STRUCTURAL EVALUATION OF  
WASHINGTON ELEMENTARY SCHOOL  
WEST CONTRA COSTA UNIFIED SCHOOL DISTRICT  
(WCCUSD)

April 30, 2002

DASSE Design Project No. 01B300

Figure 13: Electrical conduit at portables

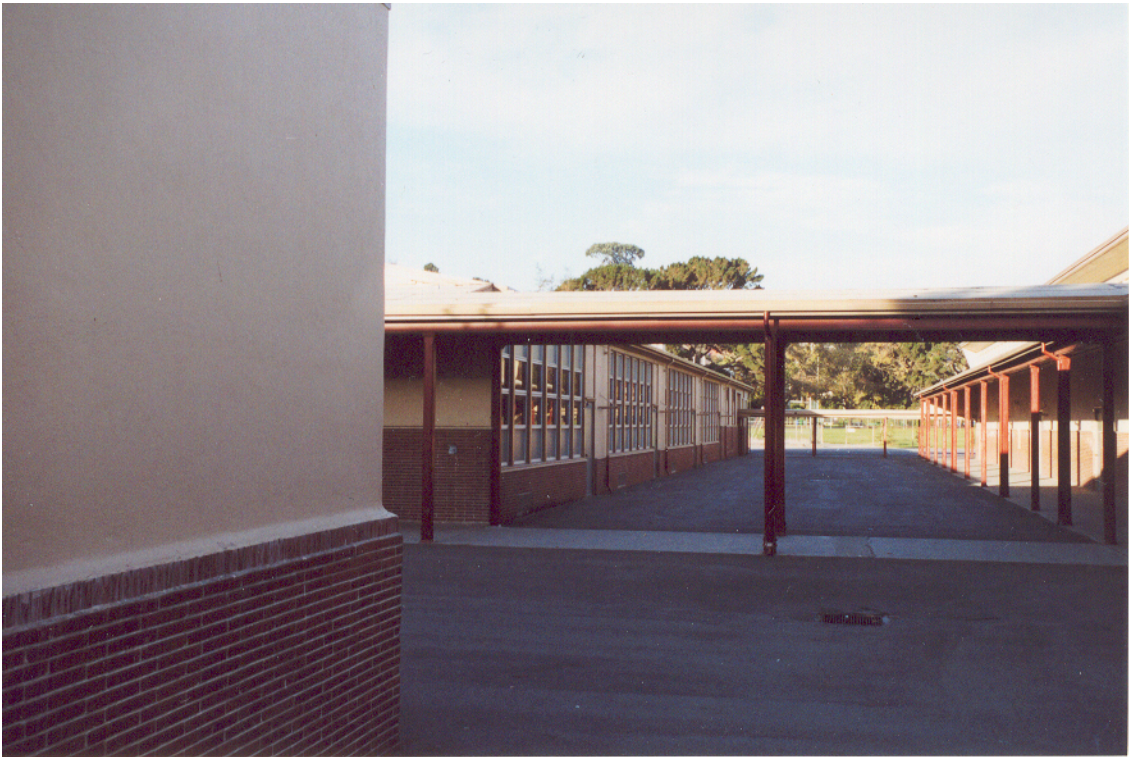
7.	The brick chimney at the south classroom building that may collapse during an earthquake.
8.	The electrical conduit running between the portable classrooms near the roof level has no flexible connection. It may be damaged as the buildings move independently.

7.	Remove the existing chimney or provide new bracing of chimney to the roof	1.3	5, 8
8.	Provide new flexible conduit connections at seismic joints	1.9	13

4.	The covered walkway near room number 19 has deteriorated.
5.	Where the covered walkway connects to the main building, the walkway is hung from the building roof by 3/4” dia. rods. There is inadequate seismic bracing of the walkway at this location.

4.	Demolish existing covered walkway and build a new one.	2.5	10
5.	Provide new steel posts and piers at ends of beams	2.5	12
6.	Provide a new seismic joint and add new columns and footings under the existing beams for gravity and lateral support	1.6	9

6.	The covered walkway from near room number 10 to room number 15 is connected to both classroom buildings and may be damaged and collapse as the buildings move independently.
